SERVICE BULLETIN

SERVICE BULLETIN		No.: MSB-00E35-001		
		Date: 2000-05-30		
Subject:	CHANGE TO ERASING OF ABS DIAGNOSTIC CODES		<Model>	<M/Y>
			(EC)COLT/LANCER (CKOA,CJOA)	96-10
Group:	SERVICE BRAKE	Draft No.: 99AL122308	(EC)PAJERO (V10, 20, 30,40)	95-10
			(EC)L400 (PA0 to PD0)	95-10
			(EC)PAJERO SPORT/MONTERO	99-10
			SPORT	
			(K80W, K90W)	
INFORMATION/ CORRECTION	INTERNATIONAL CAR ADMINISTRATIO OFFICE	 T.NITTA - PROJECT LEADER AFTER SALES SERVICE & CS PROMOTION	(EC)L200 (K60, k70)	97-10

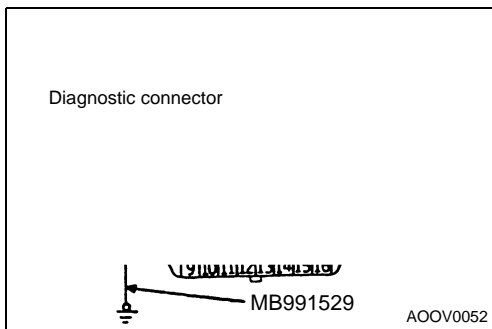
When diagnostic trouble codes (Nos. 21 to 24) (for vehicle wheel speed sensor system failures) occur, normal MUT-II operation may not erase those codes. In that case, erase the diagnostic trouble codes using the following procedures.

1. Perform erasing of the diagnostic trouble codes by special operation of the brake pedal. (See erasing procedure for the diagnostic trouble codes without use of the MUT-II.)
2. Turn the ignition switch OFF.
3. Perform erasing of the diagnostic trouble codes by use of the MUT-II.

4. Ensure that the diagnostic trouble codes have been erased. When diagnostic trouble codes
